CWS File Number
22-001888

Service Provider Letter

Jurisdiction: <u>City of Beaverton</u>	Review Type: <u>No Impact</u>
Site Address / Location: <u>SW Greenway</u> <u>Beaverton, OR 97008</u>	SPL Issue Date: <u>October 07, 2022</u> SPL Expiration Date: <u>October 06, 2024</u>

Greenway Park Restroom Addition

Figure 2: Proposed Project Details

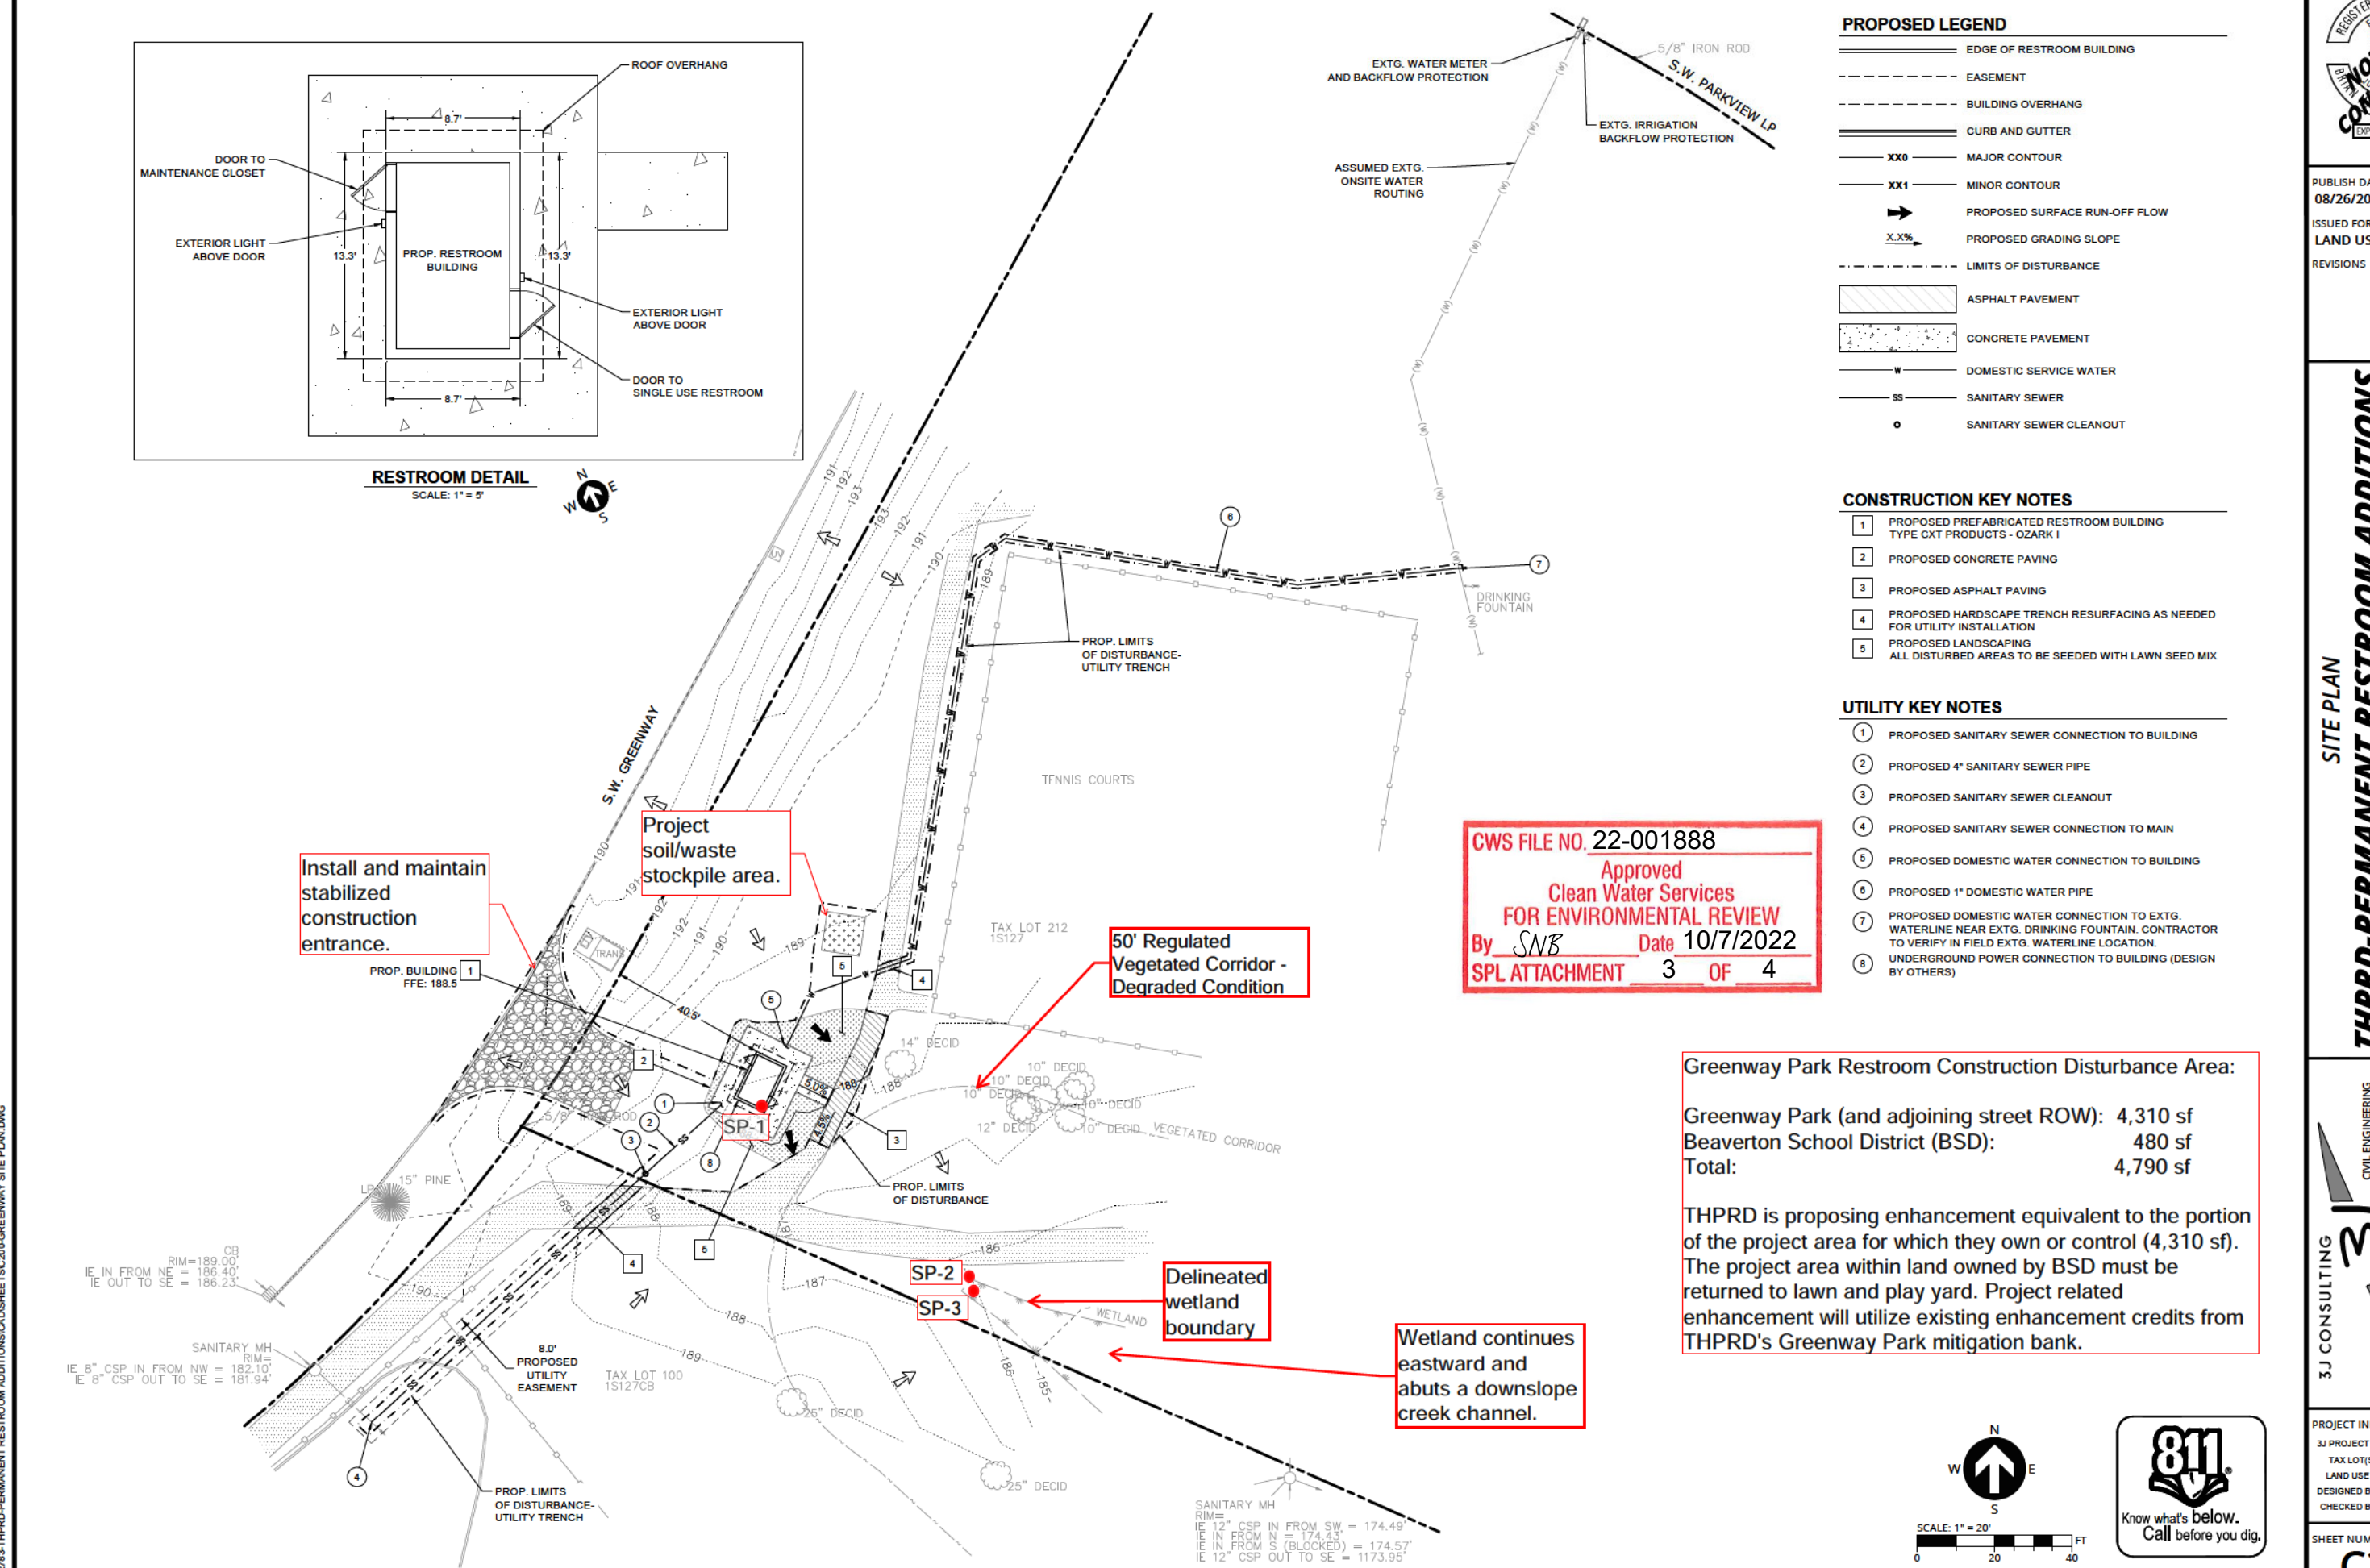
Greenway Park Restroom Construction Disturbance Area:
 Greenway Park (and adjoining street ROW): 4,310 sf
 Beaverton School District (BSD): 480 sf
 Total: 4,790 sf
 THPRD is proposing enhancement equivalent to the portion of the project area for which they own or control (4,310 sf). The project area within land owned by BSD must be returned to lawn and play yard. Project related enhancement will utilize existing enhancement credits from THPRD's Greenway Park mitigation bank.
